MONTGOMERY COUNTY HISTORIC PRESERVATION COMMISSION
STAFF REPORT

Address:	12 Hesketh Street, Chevy Chase	Meeting Date:	9/17/2025
Resource:	Contributing Resource Chevy Chase Village Historic District	Report Date:	9/10/2025
Applicant:	Matthew Brest (Ethan Santos, Agent)	Public Notice:	9/3/2025
Review:	HAWP	Tax Credit:	n/a
Case Number:	1129402	Staff:	Laura DiPasquale
Proposal:	Demolition and replacement of an accessory structure

Staff recommends that the HPC **approve** the HAWP, with final approval authority delegated to staff.

Figure 6: Existing conditions photographs of the front (north) and east side elevations.

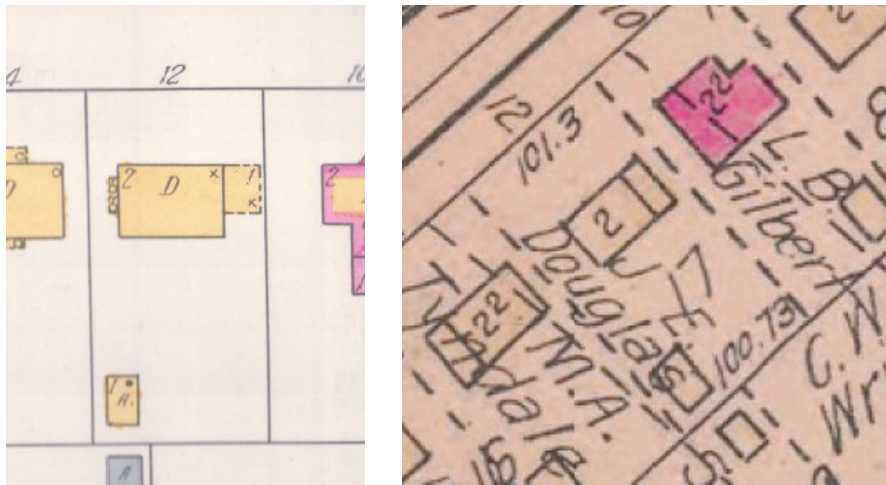
Staff supports the proposed project and recommends approval. Staff finds that the existing accessory structure, identified by the applicants as a "shed," was originally constructed as a garage for the property (see Figure 7). The *Amendment* includes a survey of resources in the district and identifies some accessory structures, including this structure, as "contributing". The *Guidelines*, state that detached garages should be subject to lenient scrutiny but should also be compatible with the main building. Staff finds that, although the demolition of the accessory structure could be considered removal of historic fabric and run counter to *Standards 2 and 9*, per Chapter 24A-1.5.b, "where guidance in an applicable master plan, sector plan, or functional master plan is inconsistent with the Secretary of the Interior's Standards and Guidelines for Rehabilitation, the master plan guidance shall take precedence."
